**Re: TLC Pet and Uptown Cat Hospitals, 1300 Wyoming Boulevard, N.E.  
Traffic Circulation Layout**  
Engineer's/Architect's Stamp dated 10-24-14 (J20-D027)

PROJECT TITLE: TLC Pet and Uptown Cat Hospitals

**Re: TLC Pet and Uptown Cat Hospitals  
1300 Wyoming Boulevard, N.E.  
Request for Traffic Circulation Layout (TCL) for Building Permit Approval**

2 H.C. Ramp Detail

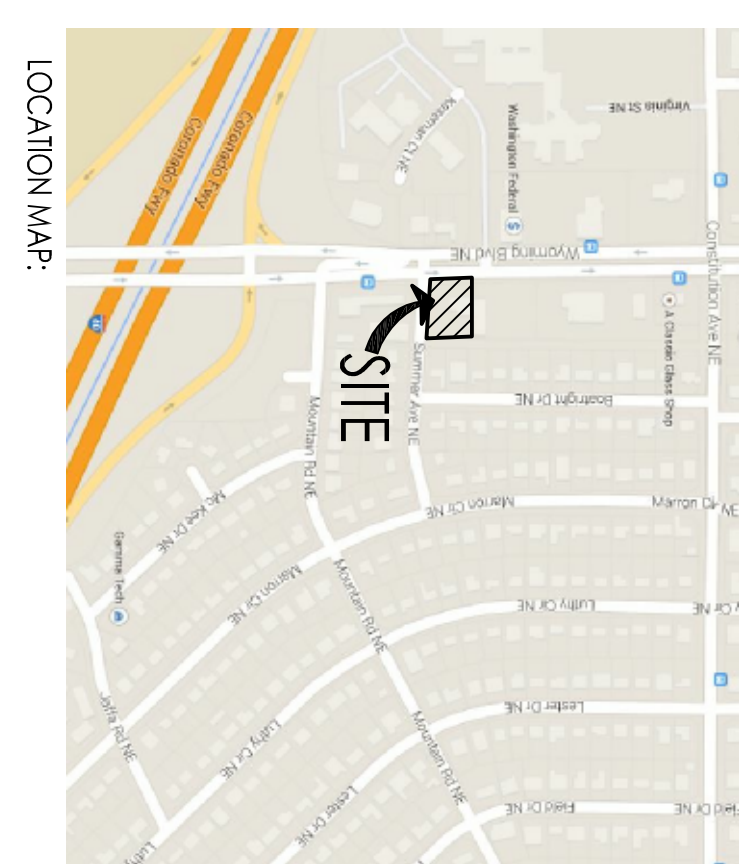
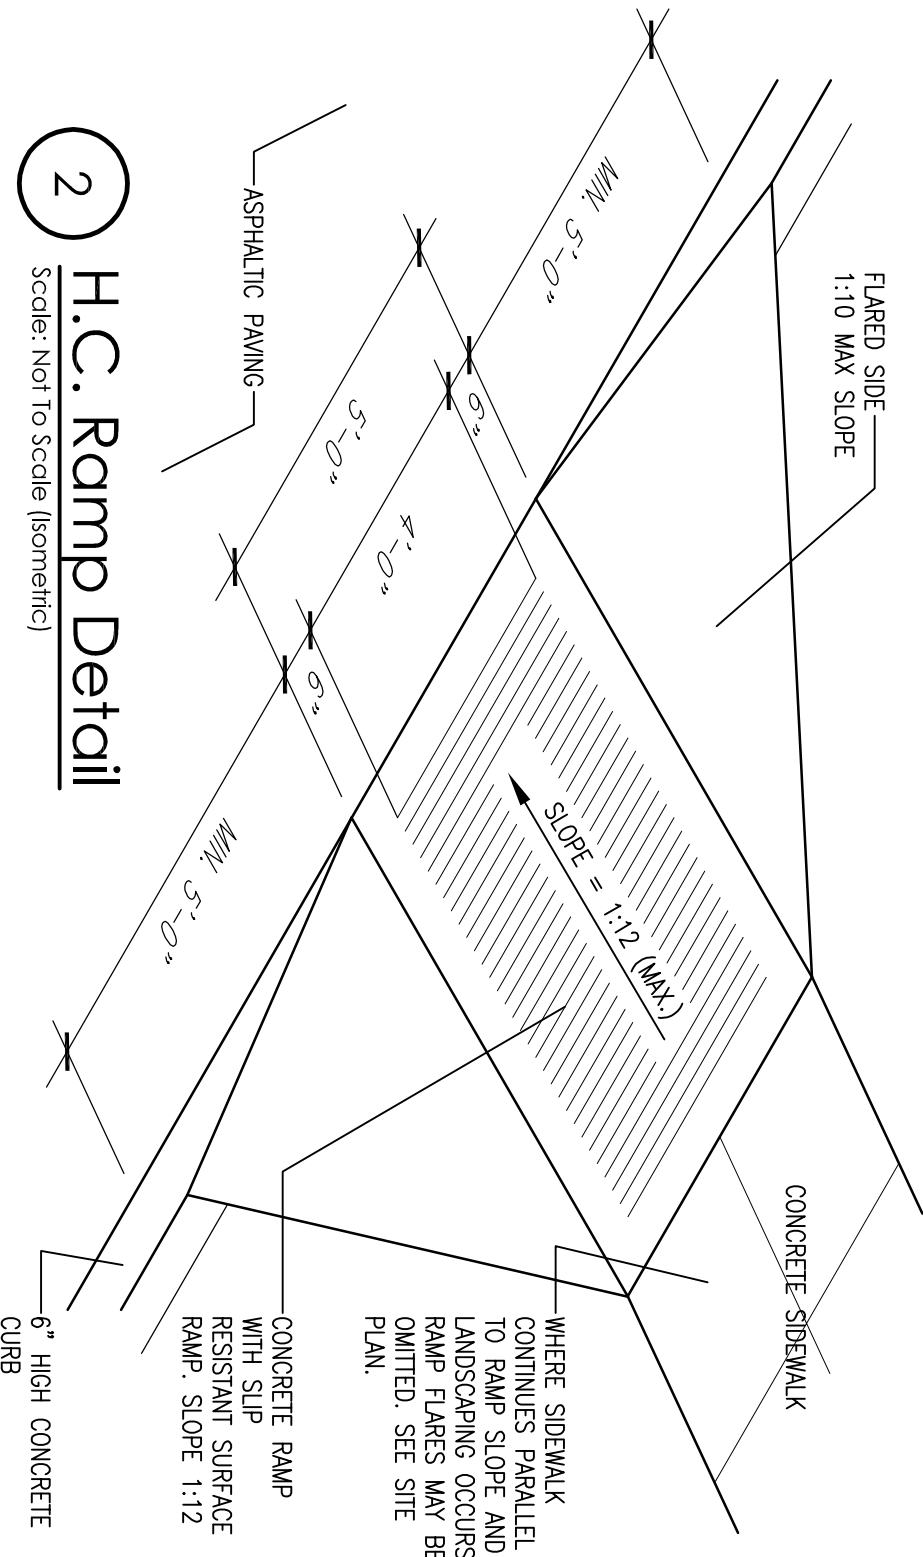
9. Graphically, it appears that it will be difficult to incorporate a 6-foot wide flat ADA-accessible path in front of the door in addition to a ramp with a 12:1 slope. (Make sure that both the 12:1 ramp and a 6-foot pathway can be incorporated. The ramp is only drawn at a 5-foot length).  
*The drive aisle along the south side of the building has been reduced to 22', since parking only occurs on one side of the drive aisle, to allow for a greater sidewalk against the building, which also allows for 6' from the top of the HC ramp to the building. Additionally, the ramp detail indicates a 1:12 slope.*

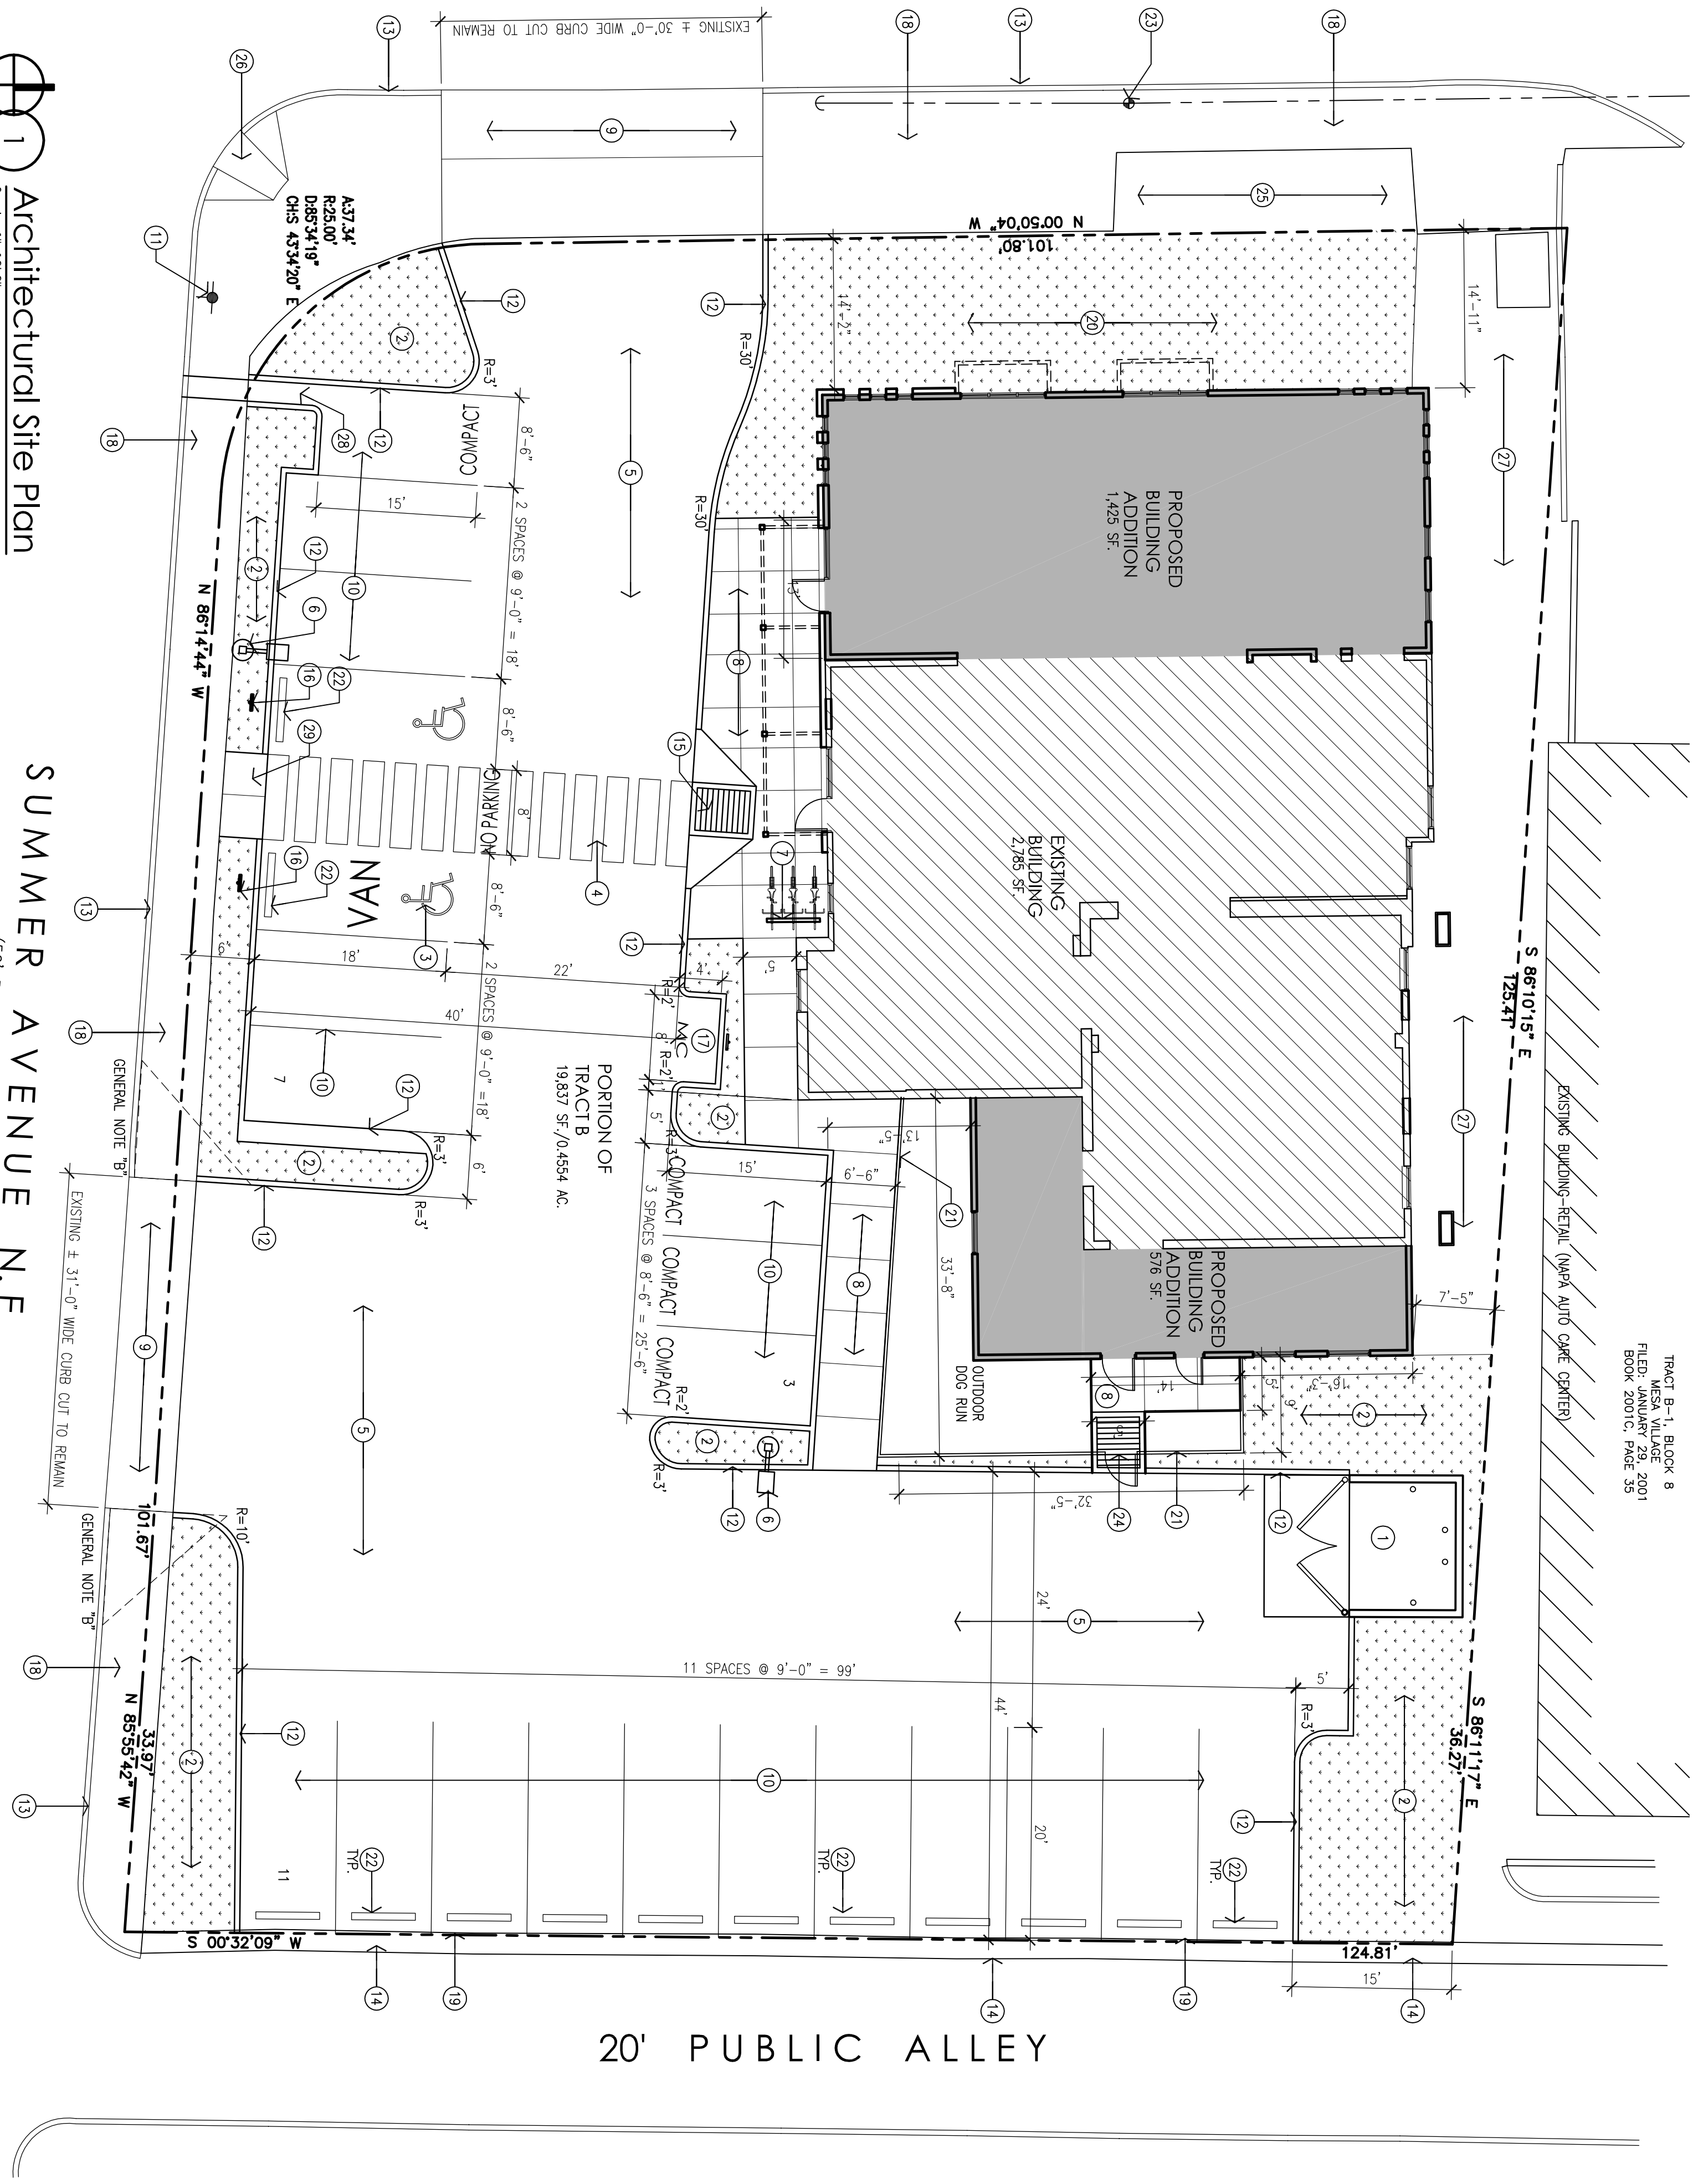
1. Please provide a vicinity map with the location of the site development in relation to surrounding streets.  
*Vicinity map, indicating the project location, is now on the site plan.*

2. Please provide a legend for the various line-types and hatching.  
*In lieu of a legend, the various line types (i.e. property lines) and hatches (i.e. new construction, existing construction and landscaping) are noted as such.*

3. Identify the existing right-of-way width, medians, and street widths for Wyoming Boulevard and Summer Avenue.  
*Right-of way and street widths are noted for Summer Ave and Wyoming Blvd.*

4. In addition to being too close to the Summer Avenue intersection, the existing drivepad on Wyoming Boulevard does not match up with the driving aisle. Revise the existing drivepad to match up with the driving aisle along the south side of the access.  
*Per our subsequent discussions, the curb returns from the drive aisle have been modified to match up with the existing drive pad.*

5. On the southwest corner of the parking lot make a correction from 3 Spaces to "2 Spaces @ 9'-0" = 18".  
*Correction made.*
6. For Keyed Note 16, the ADA van accessible sign must have the required language per 66-7-352.4C NMSA 1978 "Violators Are Subject to a Fine and/or Towing."  
*Keyed note 16 now includes this language.*

7. The ADA access aisle shall have the words "NO PARKING" in capital letters each of which shall be at least one foot high and at least two inches wide placed at the rear of the parking space so as to be close to where an adjacent vehicle's rear tire would be placed (66-1-4.1.13 NMSA 1978).  
*This has been noted on the site plan.*

8. See Figure 23.7.2 of the DPM for end of parking aisle islands Change the curb radii from 1 foot to 3 feet where shown on parking aisle islands near the end of the parking spaces. Curb radii should be 15 feet for passenger vehicle maneuvering.  
*Radii have been increased where possible.*

10. Call out curb height for Keyed Note 12. Keyed Note 12 needs to correctly point to curb for access off of Wyoming Boulevard.  
*Correction made.*
11. For ease of refuse vehicle maneuvering, move the refuse at least a few feet to the east away from the curb.  
*Approval by the refuse department is indicated on the site plan.*

12. Indicate what pavement thickness will be used for the parking lot.  
*Existing asphalt is to remain and only be resurfaced. Keyed note 5 indicates this.*

13. The proposed landscaping at the access off of Summer Avenue may interfere with the sight distance. Provide clear site triangle. (See DPM Manual Page 23-74 of the DPM for Mini Clear Site Triangles for Driveways.)  
*Clear site triangles are indicated at the drive pad off of Summer Ave.*

14. Please add the following note to the clear sight triangle: "Landscaping and signage will not interfere with clear sight requirements. Therefore, signs, walls, trees, and shrubbery between 3 and 8 feet tall (as measured from the gutter pan) will not be acceptable in this area."  
*Note included as General Note B.*

15. Please specify the City Standard Drawing Number when applicable.  
*City Standards are noted where applicable.*
16. Work within the public right of way requires a work order with DRC approved plans.  
*If right-of-way work is required, DRC plans will be produced. General Note D indicated that no public work is anticipated.*
